**CITY OF KELOWNA  
MEMORANDUM**

**Date:** February 8, 2008  
**To:** City Manager  
**From:** Planning & Development Services Department  
**APPLICATION NO.** Z07-0011      **APPLICANT:** Axel Hilmer  
**AT:** 605 Monterey Rd.      **OWNERS:** Marcel Gal  
Bertha Gal

**PURPOSE:** TO REZONE THE SUBJECT PROPERTY FROM THE RU1 – LARGE LOT HOUSING ZONE TO THE RU6 – TWO DWELLING HOUSING ZONE IN ORDER TO CONSTRUCT A SECOND SINGLE FAMILY DWELLING.

SITE PLAN 1/8" = 1'-0"

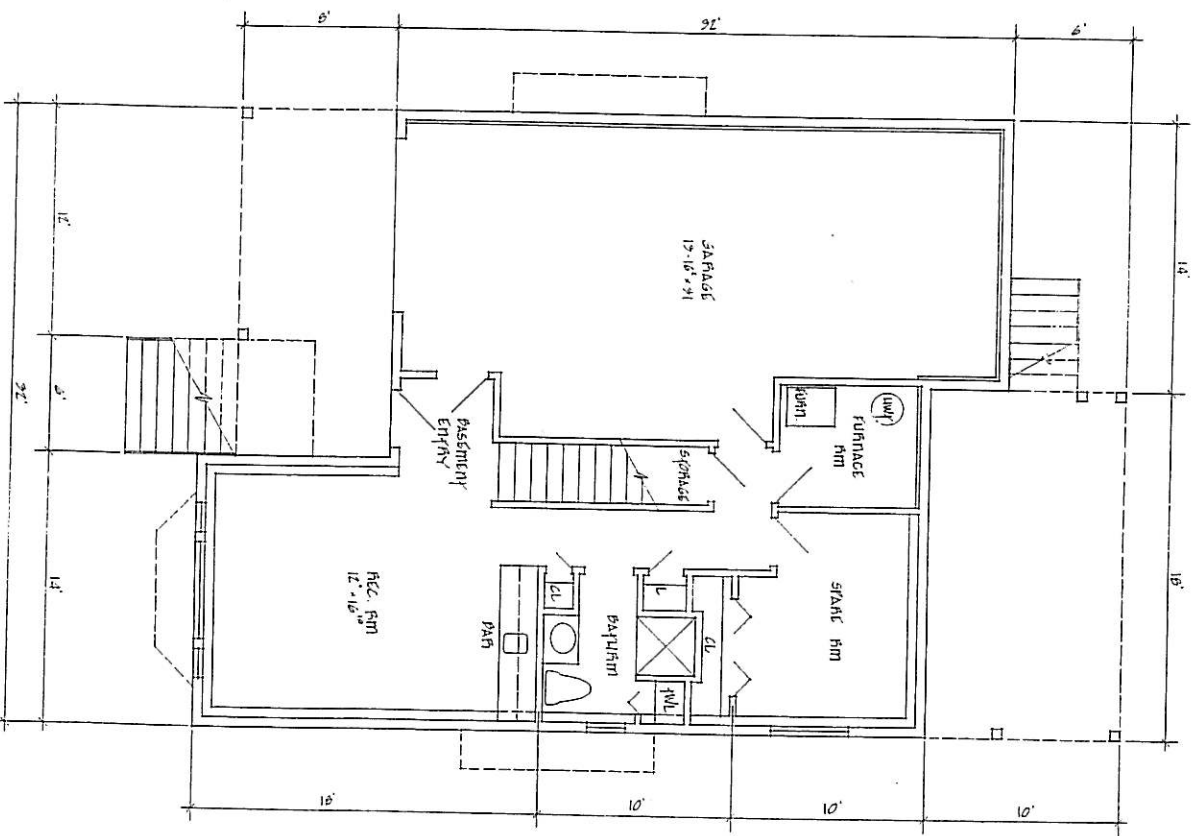
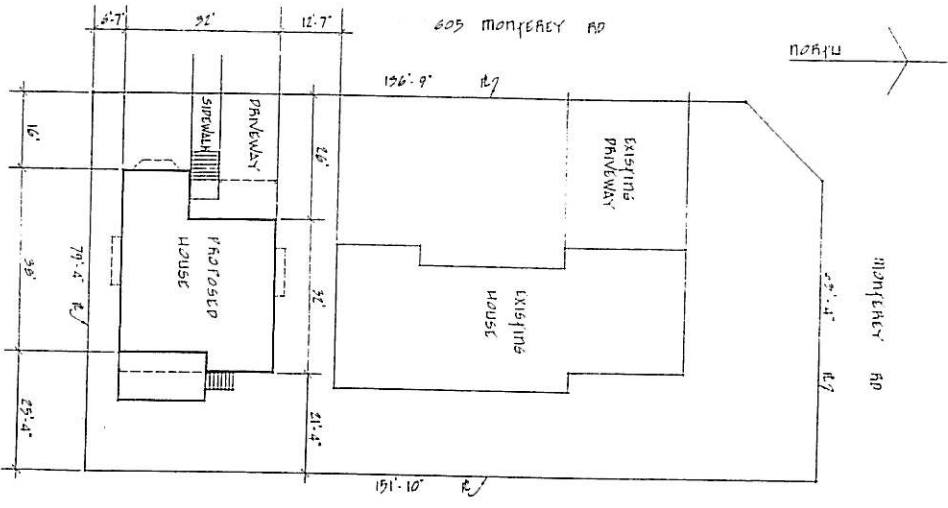
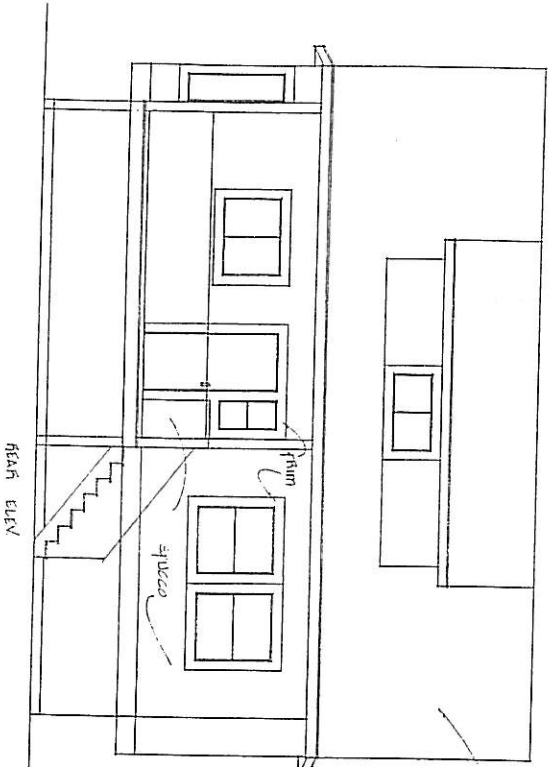
<sup>A</sup> The site plan shows a 6.5 m dimension to the proposed house, where the actual measurement should be to the raised deck portion of the structure, which is ± 2.1 m from the east property line.

Staff has concerns with this proposal, relating primarily to the siting of the second dwelling unit. Although this lot is well suited to the RU6 zone, in terms of lot area, width, and road access (corner lot), the existing home makes an infill project difficult, given its current location near the mid-point on the lot.

Notwithstanding the difficulty and cost, a more appropriate infill of this lot would necessitate the demolition or relocation of the existing home. There is room on the north end of the property, for example, and the parking could be better configured such that it also consumes less lot area.

Although Staff is not opposed to rezoning the subject property to the RU6 zone, per se, there is reluctance to recommend support of that zoning, given the current proposal. Rather than try to squeeze a second principal dwelling, which is to be 235 m<sup>2</sup> (2,500 ft<sup>2</sup>) in size, and 2 ½-storey in height, and requires variances, it is recommended that the applicant consider one of the following:

- demolish or relocate the existing dwelling to free up additional land to properly site a second principal dwelling; or
- consider the RU1s zone, and add-on to the existing dwelling to accommodate a secondary suite.
